CARE Suffolk

Ref: DC/22/00683 & DC/22/01243 – Full Planning Application – Cross-Boundary Application for Installation of a solar array, battery energy storage system and associated infrastructure and construction of vehicular accesses and roadways.

Report for Full Planning Application

DC/22/00683 & DC/22/01243

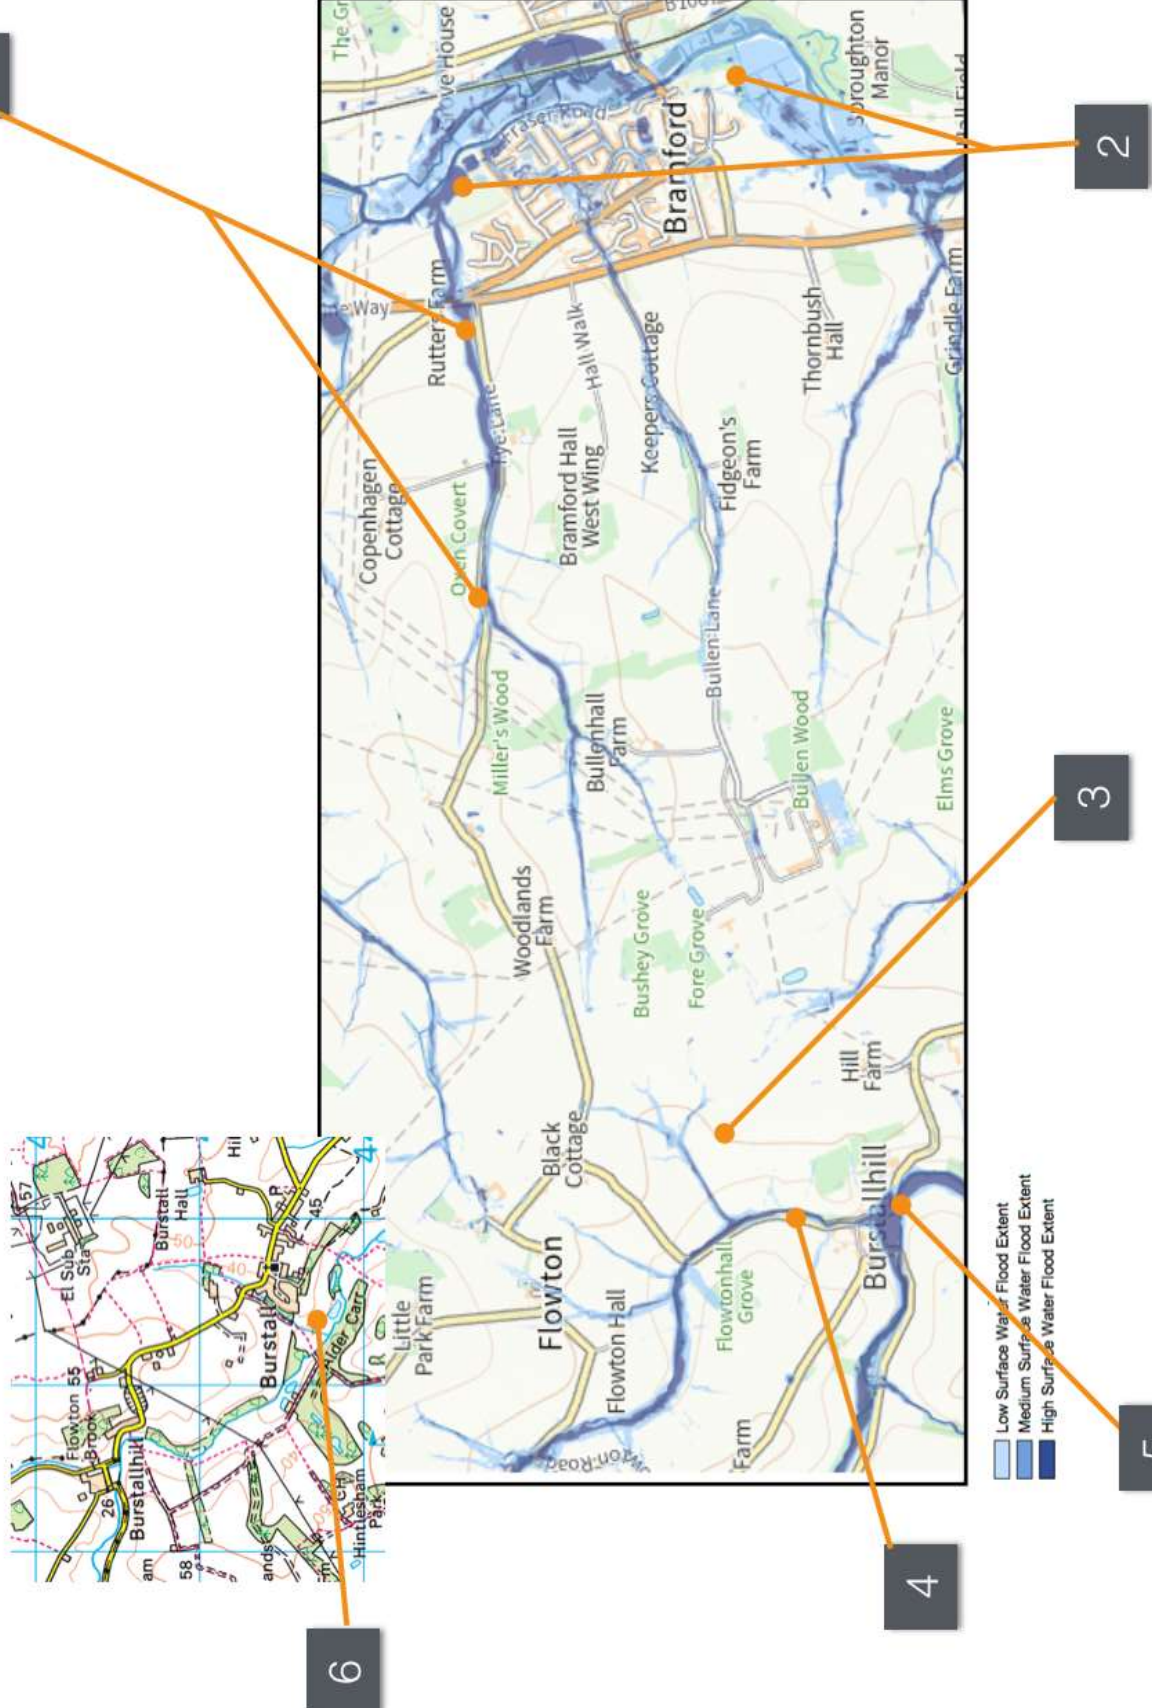
It is our assessment that without a comprehensive quantitative analysis of the above factors it is simply not possible to determine the degree to which the flood risk will be elevated by the activity & construction proposed by the applicant. And without this analysis it is also not possible to provide assurance to those likely to be impacted by flooding emanating from the site that any proposed mitigation would likely to be effective.

The applicant's Flood Risk Assessment does not assess the current impact of flooding associated with overground flow from the area

Proposed development DC/22/00683 - Historic flood photographic evidence (Associated with Fields 7, 4 and 5)

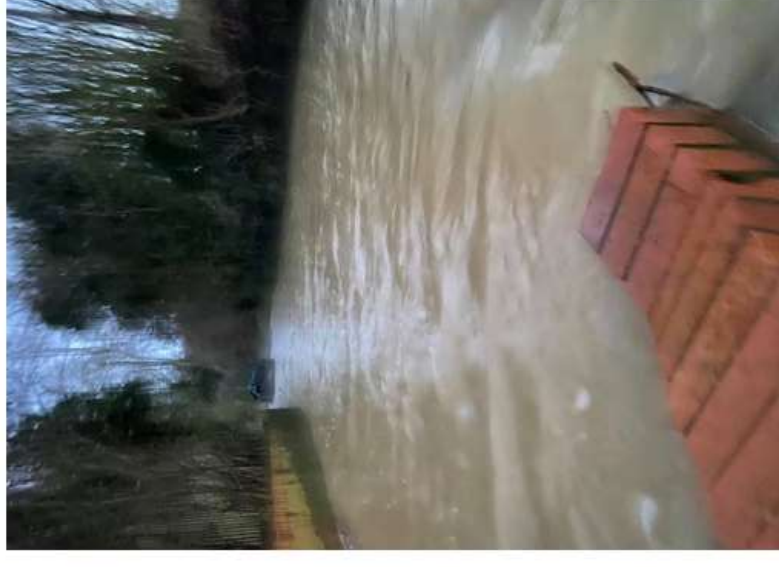
Standing water in field 5m to the south of field 7 31/01/21 observed by Angela & John Schwarz

Flooding of "Church Hill" and "The Channel" Roads from flow paths emanating from Field 7, 4 and 5 28/01/21 observed by Steve Packard

Proposed development DC/22/00683 - Historic flood photographic evidence (Associated with Fields 7, 4 and 5)

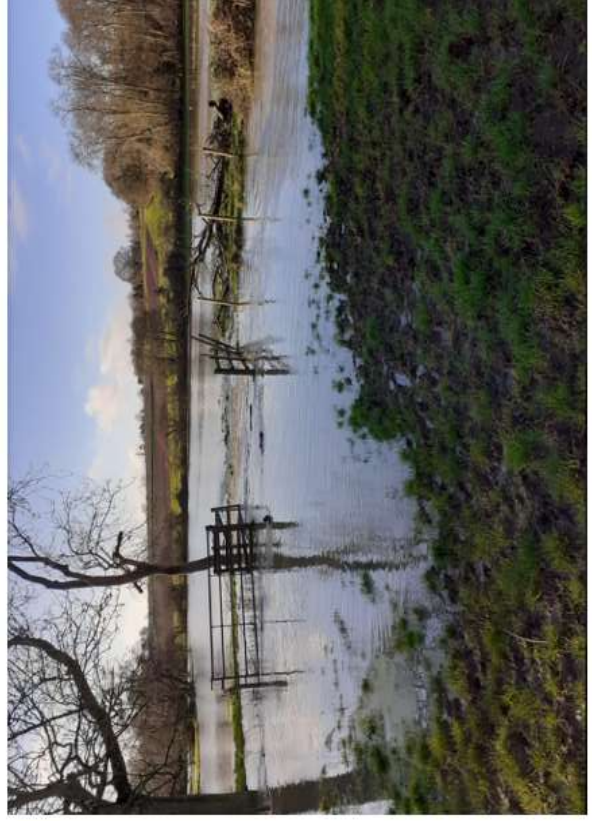
Flooding of "The Channel" Road adjacent to Fields 7, 4 & 5 15/01/21
observed by Paul Boulton

Flooding of "Church Hill" Road below Fields 7, 4 and 5 17/01/21
observed by Claire Boulton
